Re: Comments on 2013 Ten-Year Plan Submittals

## Forward Going Costs of Existing Coal Units and Probable Environmental Controls

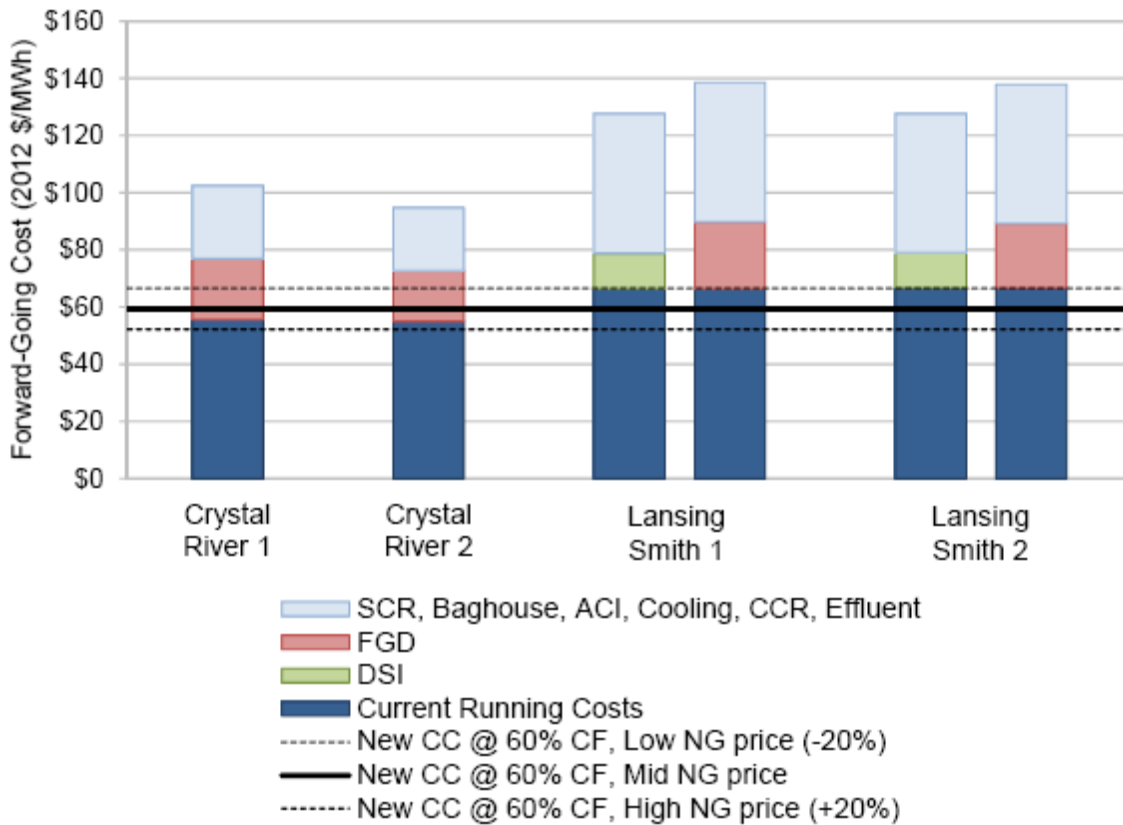
To be sure, Duke has held out the option of making short-term fuel mix adjustments which might allow the units to continue operating, perhaps as long as 2020. *Duke Compliance Plan* at 21. Continued operation would plainly be economically imprudent. As we demonstrated in our comments and workshop presentation on last year's plan, and as the figure below shows, the Crystal River units already verge on noneconomic when compared even against the substantial expense of constructing a new combined cycle natural gas plant to replace their capacity, much less against more sensible options, including demand side programs.<sup>2</sup>

As the figure above indicates, Lansing Smith 1 & 2 are even less economically attractive to operate than the uncontrolled Crystal River coal units. Gulf has not yet committed to retirement publicly, but its filings in this docket and in the Environmental Cost Recovery docket make clear that it is preserving that option.
